Advisory Board on Radiation and Worker Health
National Institute for Occupational Safety and Health

Summary of Key Issues Concerning Internal Monitoring Completeness and Representativeness for SRS Subcontractor Construction Trade Workers

Contract No. 75D30119C04183
Document No. SCA-TR-2021-SEC002, Revision 0

March 8, 2021

Figure 1. Fraction of sCTWs monitored for non-H3 radionuclides compared to total including tritium

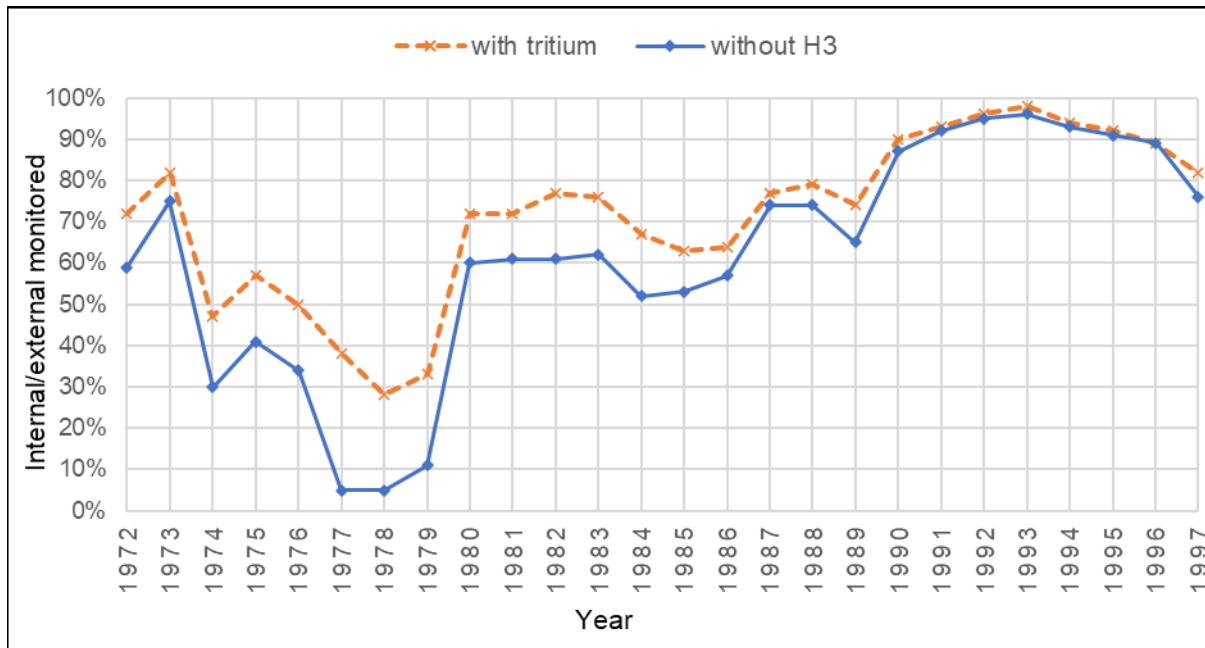
Note that for a significant number of years, the fraction of sCTWs internally monitored decreased when going from using all internal monitoring methods, which includes tritium bioassays (top plot), to non-H3 monitoring (bottom plot), especially during the 1970s and 1980s.

It should be noted that tritium bioassays were included in deriving the 63 percent and 28 percent values. In fact, for 1978, 25 percent of the sCTWs had tritium bioassays and only 5 percent had non-H3 monitoring (some workers had both tritium and non-H3 monitoring; therefore, the total does not add up to 30 percent).

Figure 2. Percentage of externally monitored subcontractor claims with plutonium bioassay in same year

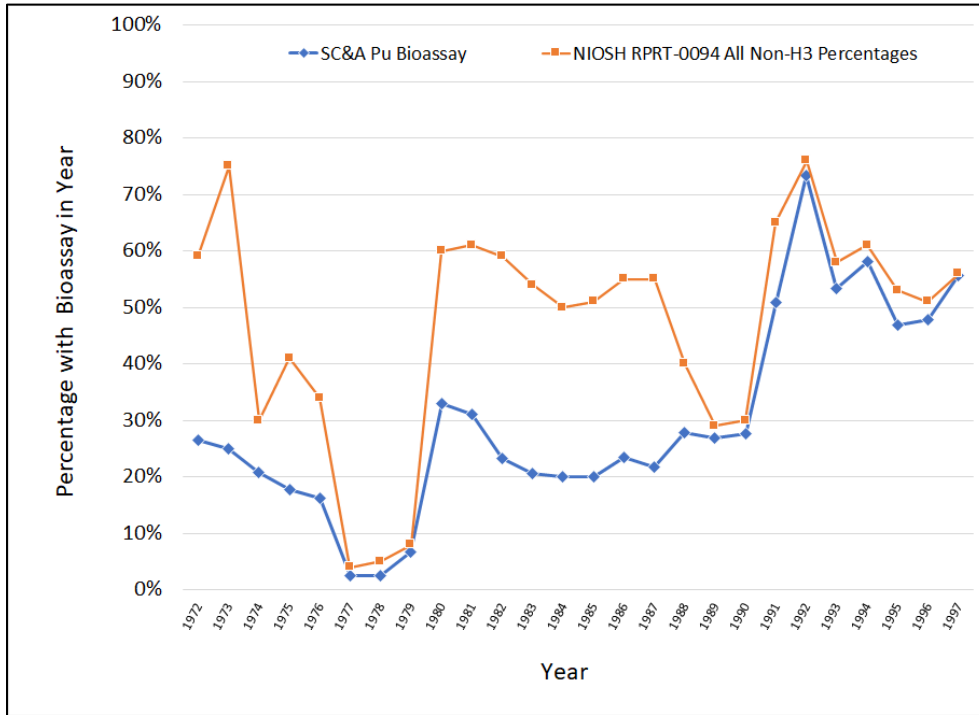
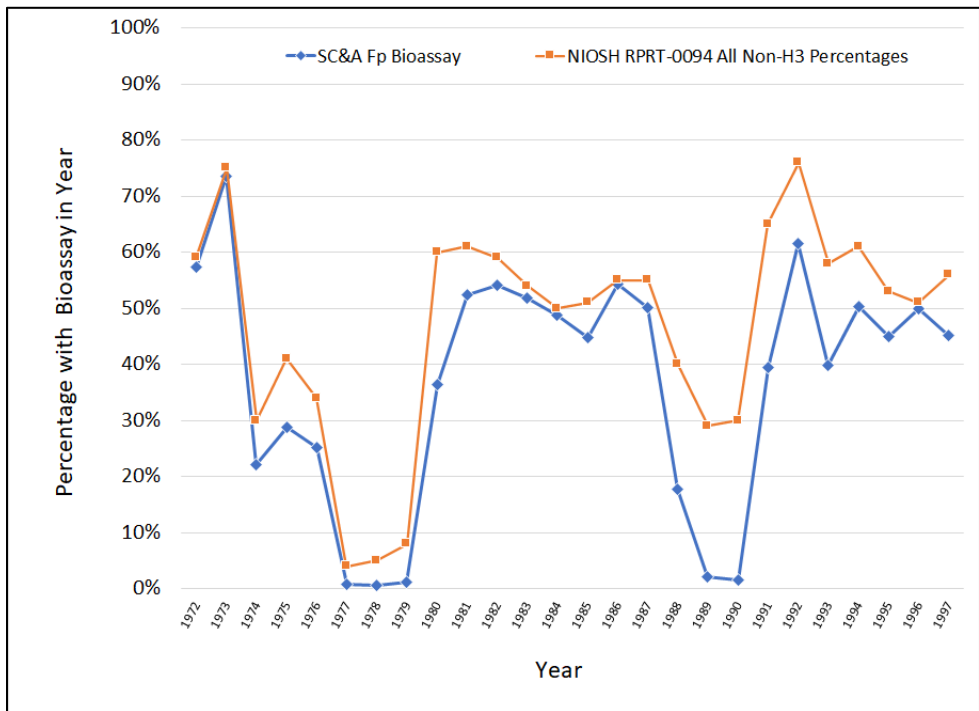
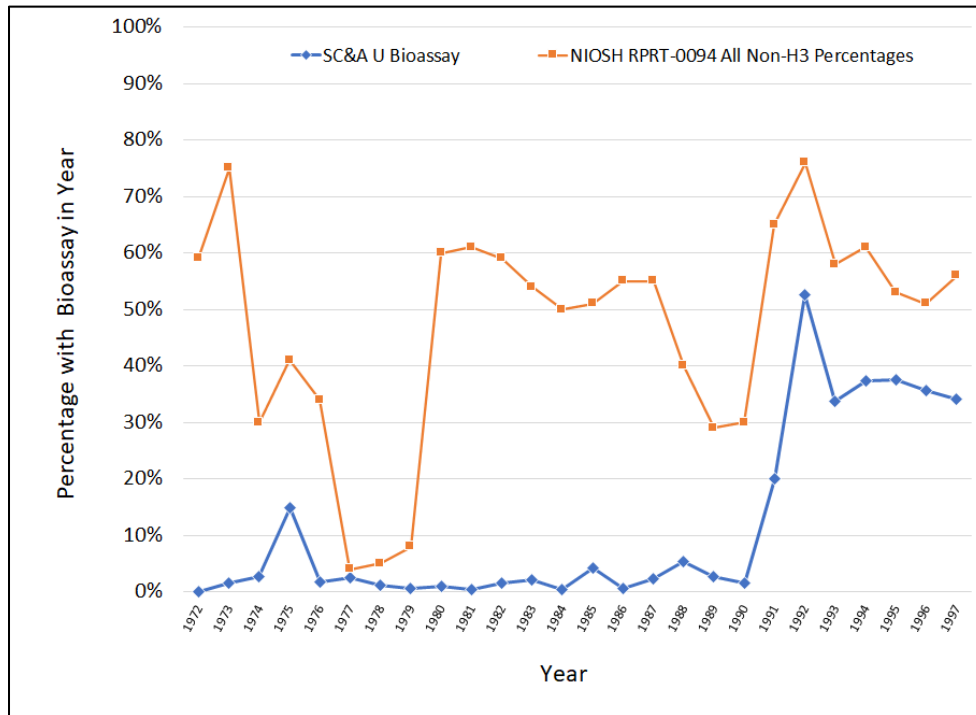
As shown in figure 2, plutonium bioassay coverage ranged from 2.4 percent in 1978 to 73.1 percent in 1992; however, if only the DuPont era⁴ of interest is considered, the maximum percentage drops to 32.8 percent in 1980. Figure 3 shows that fission product bioassay coverage ranged from 0.6 percent in 1978 to 72.5 percent in 1973. Figure 4 shows that uranium bioassay coverage ranged from 0.0 percent in 1972 to 52.4 percent in 1992; however, if only the DuPont era of interest is considered, the maximum percentage drops to 14.7 percent in 1975. For comparison, the far-right column of table 1 (column 7) shows the percentage of workers monitored for all non-tritium bioassay as provided in table 5-3 of RPRT-0094. The RPRT-0094, table 5-3, results are also plotted in figures 2–4 to illustrate the individual differences for these radionuclides.

Not surprisingly, the RPRT-0094 percentages for all non-H3 bioassay are significantly higher than the SC&A evaluation for many years and radiation types. This is particularly evident for many years during the DuPont era. However, beginning in 1988, the bioassay percentages calculated by SC&A show significantly better agreement with the RPRT-0094 percentages for non-H3 bioassay. SC&A observes that during this latter period, often plutonium, uranium, and fission product bioassay were all collected on the same date for the individual worker.

Finding 4: When non-tritium bioassay is separated into the individual radiological assay components (plutonium, fission products, uranium, neptunium, and americium), the percentage of monitored subcontractor workers decreases markedly for many years during the DuPont era.

Figure 5. Comparison of the number of subcontractor claims with external dosimetry associated with 773-A versus those also monitored via americium urinalysis per year

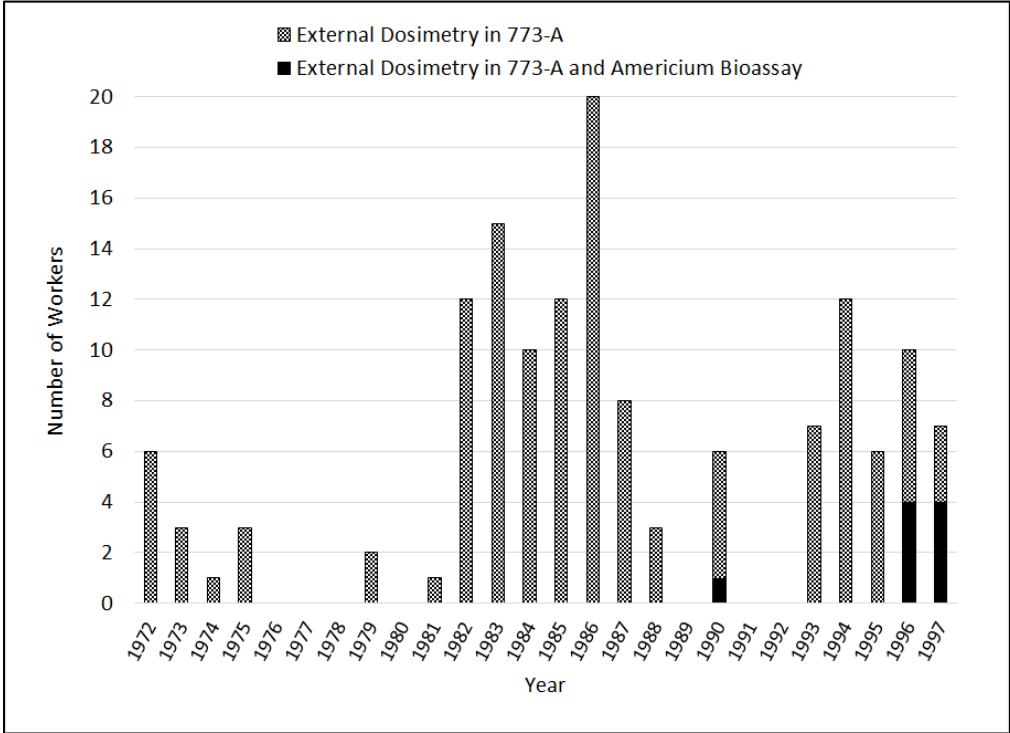
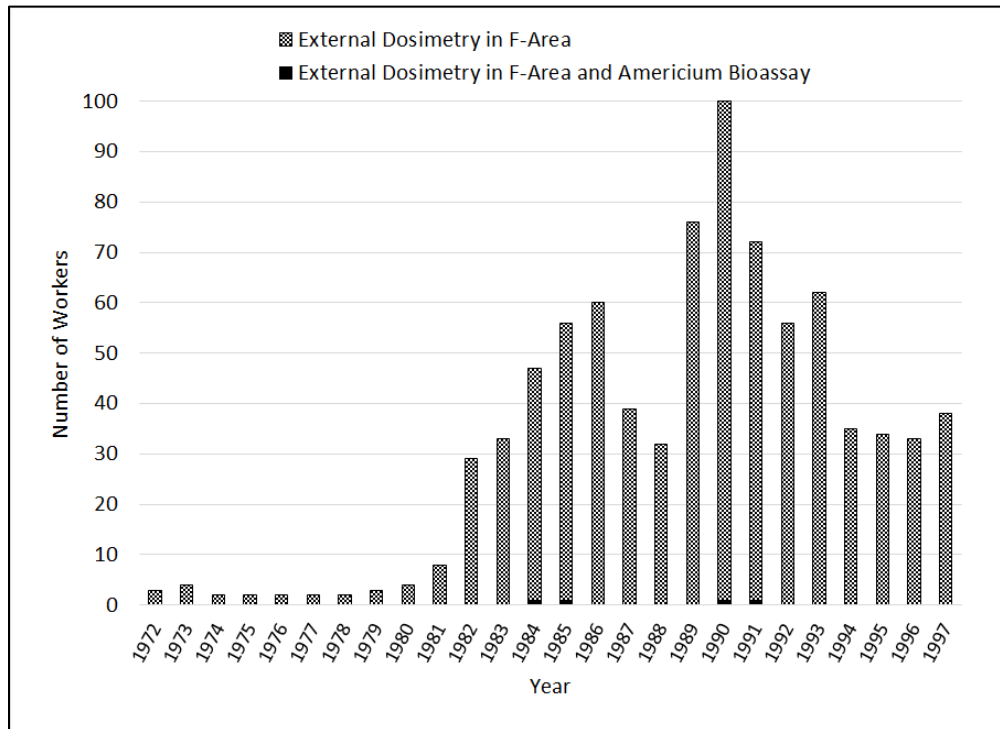
The percentage of workers with observed dosimetry and bioassay results for americium is shown in figures 5 and 6 for 773-A and F-Area, respectively. As seen in figure 5, americium bioassay and 773-A dosimetry matches were only observed in 1990 (16.7 percent), 1996 (40 percent), and 1997 (57.1 percent). It is noteworthy that the percentage of monitored workers in 773-A in 1990 (16.7 percent) reasonably matches the percentage of monitored workers identified with 773-A F-

Specific to the F-Area (figure 6), external dosimetry and americium bioassay matches were only observed in 1984 (2.1 percent), 1985 (1.8 percent), 1990 (1.0 percent), and 1991 (1.4 percent). It should be noted that while the MPPF was constructed in 1972, the facility did not appear to start full operations until approximately 1978. It is also not clear what level of operation occurred at the MPPF throughout the period of interest and whether there were significant periods where the facility was shut down and/or placed in standby mode.

Observation 1: A limited, area-specific analysis of dosimetry codes with americium bioassay showed a very low percentage of bioassay coverage with the exception of 1996 and 1997 (40 percent and 57.1 percent monitored via bioassay, respectively) for the 773-A area. The other year in which 773-A specific dosimetry and bioassay matches were identified (~17 percent in 1990) showed a reasonably similar percentage to the RWP analysis described in RPRT-0092 during the DuPont era (20 percent directly monitored via urinalysis or chest count for 1981–1988).

Figure 7. Summary of in vivo counting methods

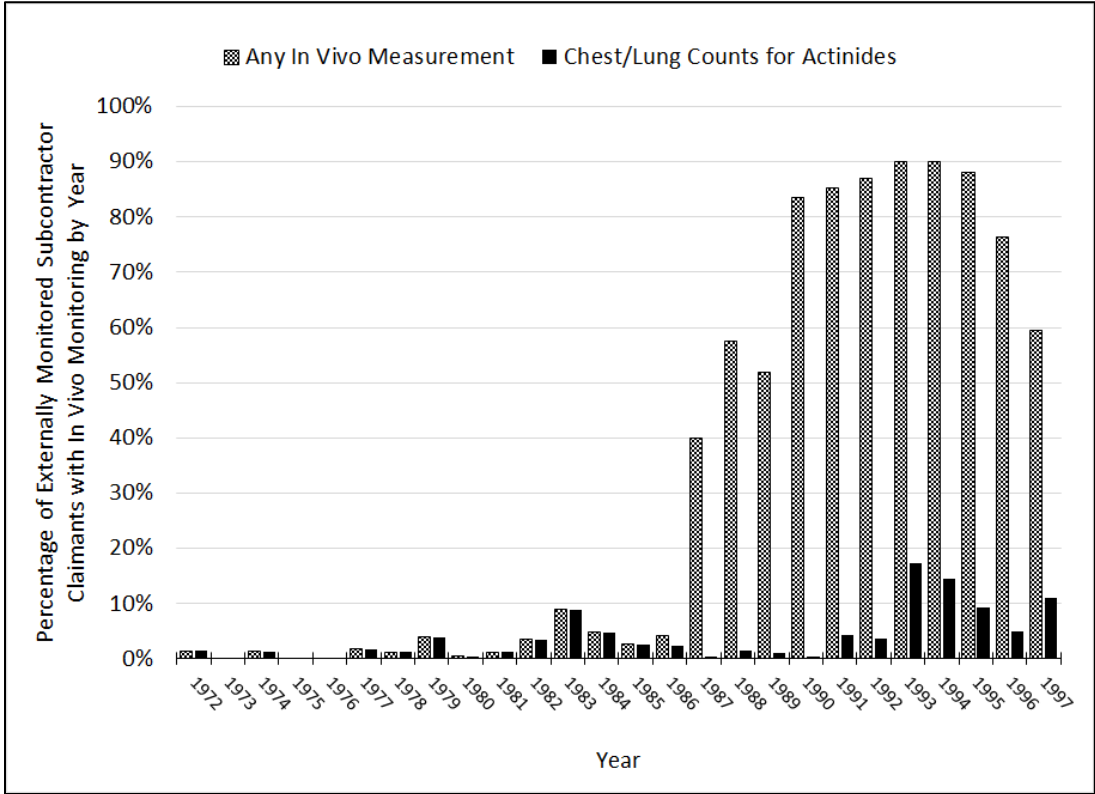
A breakdown, by year, of the number of claimants with external dosimetry and in vivo monitoring is shown in table 2 and plotted in figure 7. As seen in the table, overall in vivo

monitoring was somewhat infrequent until 1987 (generally less than 5 percent of the externally monitored population). The marked increase in 1987 coincides with the implementation of the FASTSCAN counter, which was capable of performing diagnostic measurements of individuals in a matter of 1–2 minutes but was not capable of measuring lower energy photons associated with the actinides of plutonium and americium. Chest counting (which is capable of measuring actinide material) during the DuPont era was also relatively infrequent, with the percentage monitored ranging from lows of 0 percent in 1973, 1975, and 1976 to a high of 8.9 percent in 1983. The percentage monitored via chest count was less than 5 percent for all other years during the DuPont era.

Observation 3: Chest counting capable of measuring actinide material, such as americium and plutonium, was relatively infrequent during the DuPont era and was generally less than 5 percent of the externally monitored population. Therefore, the effect on the monitoring totals for these contaminants is minimal for most years (refer to section 7 for a full analysis).

Figure 8. Combined monitoring coverage (in vitro plus in vivo) for major radionuclide categories

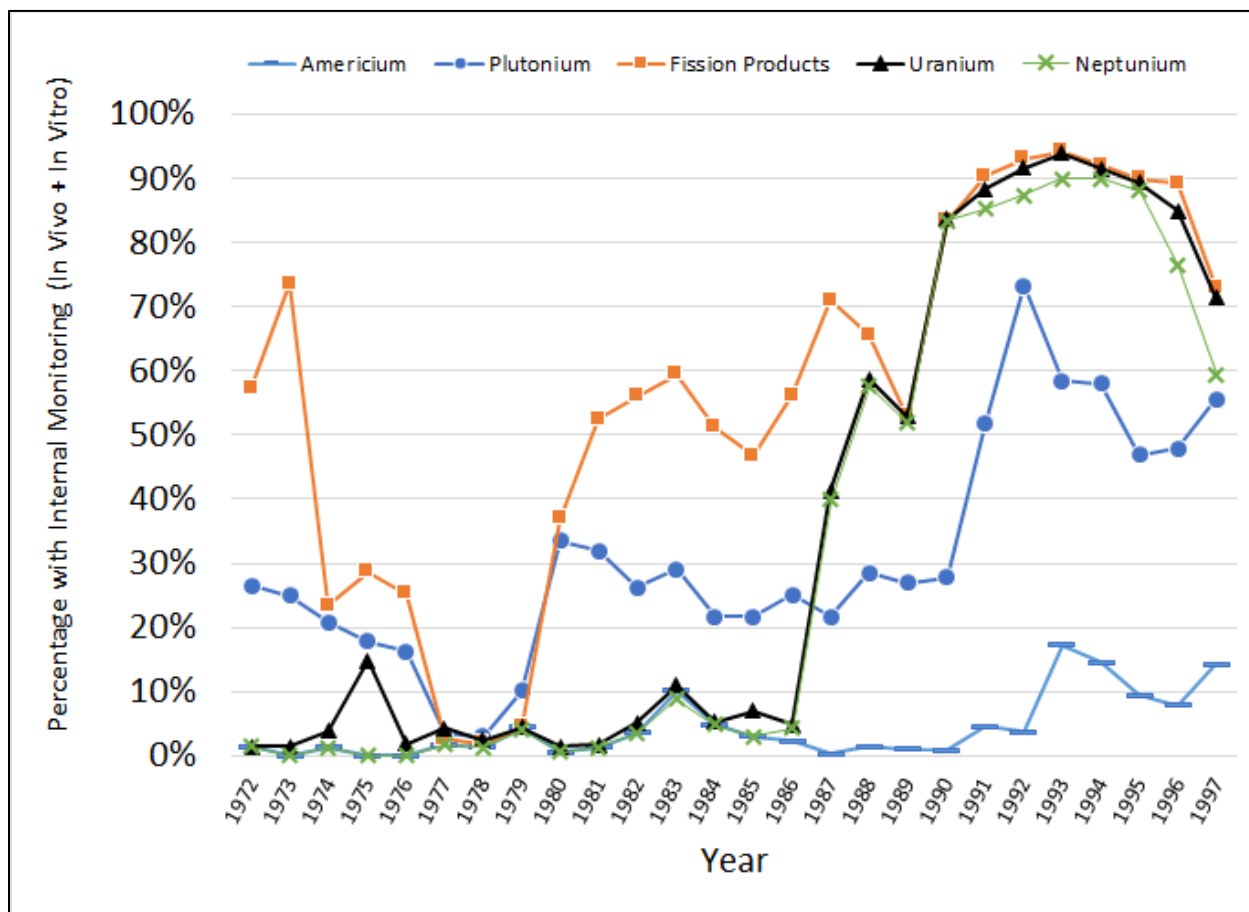
the monitoring coverage increased markedly in 1987, which coincides with increased in vivo monitoring methods that could potentially be used to detect uranium, neptunium, and fission products.

Finding 6: When considering the combination of radionuclide-specific in vitro data and applicable in vivo measurements, the percentage of externally monitored subcontractor claims with internal monitoring per year did not markedly increase until 1991 (plutonium) and 1987 (uranium and neptunium). Monitoring percentages for americium were less than ~17 percent for all years and less than ~10 percent for the DuPont era years. These values are significantly lower than the all non-tritium monitoring percentages calculated in RPRT-0094 for many years during the DuPont era.

Figure 9. Comparison of the number of subcontractor claims with external dosimetry associated with 773-A versus those also monitored via americium urinalysis or chest counts per year

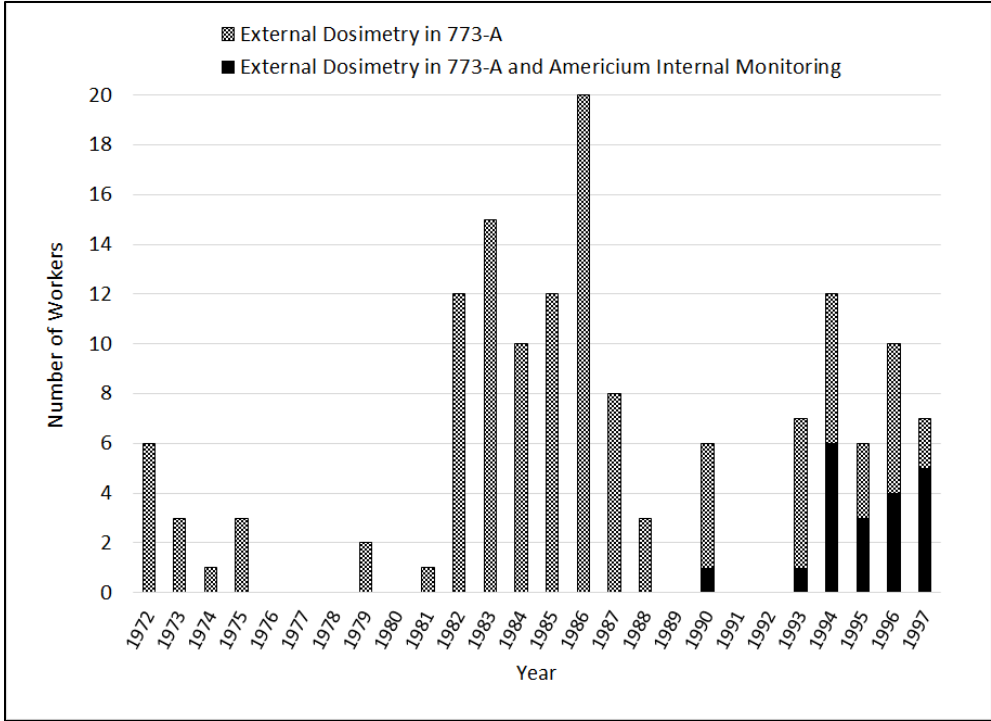
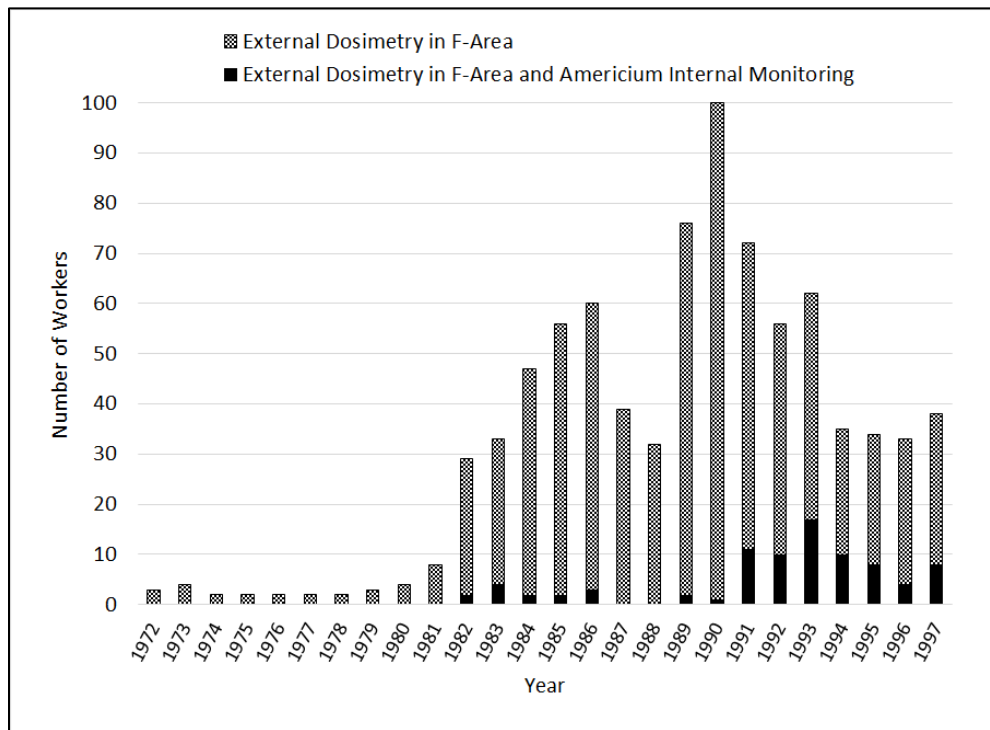
Similar to the analysis in section 5, SC&A performed an area-specific analysis for americium based on external dosimetry codes for 773-A and F-Area. The results are shown in figures 9 and 10. As seen in the figures, the inclusion of chest count data had a significant effect for the 773-A area during certain years of the WSRC era, with americium monitoring percentages ranging from 40 percent to 70 percent in the years 1994–1997. For the F-Area analysis, americium monitoring coverage ranged from 0 percent (1972–1981, 1987, and 1988) to

28.6 percent in 1994. The maximum observed percentage during the DuPont era was 12.1 percent in 1983.

Observation 5: Similar to observation 1, a limited, area-specific analysis of dosimetry codes with americium bioassay showed a very low percentage of bioassay coverage, with the exception of the late 1990s for the 773-A area. For the F-Area analysis, monitoring percentages were zero for 12 of 26 years evaluated and less than 20 percent for 22 of 26 years (including the 12 zero percentage years).
